## Planning Compliance Report

Proposed Phase 3 of Aderrig Development  
at Adamstown SDZ, Co. Dublin

**Client Name:** Quintain Ireland  
**Document Reference:** 22-023r.009 Planning Compliance Report  
**Project Number:** 22-023

Figure 1: Previously Proposed Configuration of Bus Stops

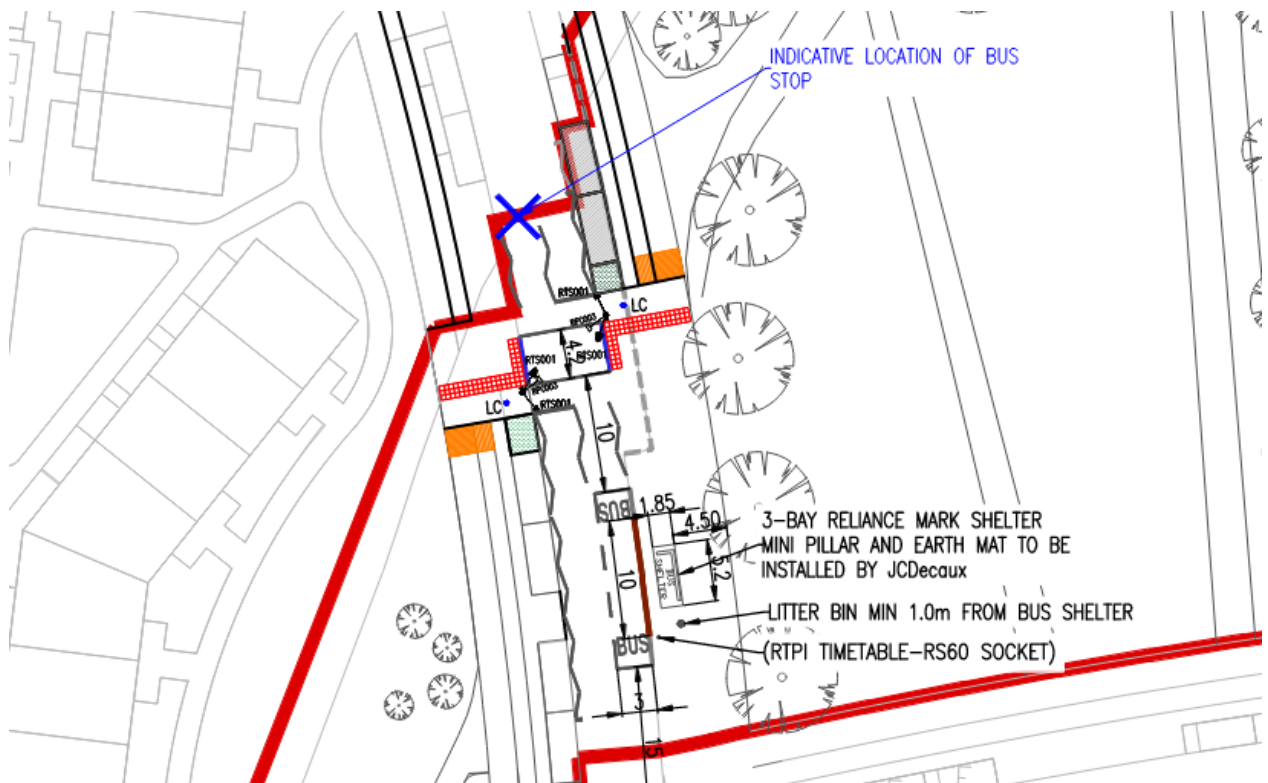
Prior to the commencement of development the applicant, owner or developer shall submit the following for the written agreement of the Planning Authority: Revised plans that incorporate all of the following amendments- (a) A location for a bus stop on both sides of the Celbridge Link Road, within the redline boundary of the application site.

It was previously proposed at the time of response to the request for further information that a set of bus stops will be provided on Celbridge Link Road at the northern end of the Aderrig Phase 3 development, in accordance with the Adamstown Strategic Development Zone Guideline, refer to Figure 1. The proposed solution, with due consideration for the surrounding infrastructure, provided two bus stops, one on either side of the proposed signalised pedestrian crossing. The original proposal remains the best technical solution for the Celbridge Link Road, where the northern and southern bus stops straddle the proposed signalised pedestrian crossing.

Where the northern-bound bus stop falls outside of the Aderrig Phase 3 site boundary there are landownership constraints between the Aderrig Phase 3 development and the Tubber Lane Development Areas. There are no conditions attached to the recent Tubber Lane Phase 3 Planning Permission (Reg. Ref. SDZ21A/0023), to deliver this design solution outside of the Aderrig Phase 3 boundary.

Following discussions with South Dublin County Council and Goodrock Project Management, it is believed that it will be a significant portion of time until the Celbridge Link Road to the north of Aderrig Phase 3 is taken in charge by SDCC. Without a mechanism to deliver the previously proposed design extents outside of the Aderrig Phase 3 development, and until such time that the Celbridge Link Road is taken in charge, a temporary northern-bound bus stop is proposed within the Aderrig Phase 3 development red line boundary on Celbridge Link Road to satisfy condition 2A, refer to Figure 2. The proposed temporary northern-bound bus stop will satisfy any demand from the Northern bound C4 bus route, proposed by the NTA, until such time that the finalized bus stop is constructed. Once the Celbridge Link Road is taken in charge, the northern-bound bus stop can be constructed in the proposed finalized location, as per Figure 1, and the temporary bus stop located within the Aderrig Phase 3 boundary can be removed.
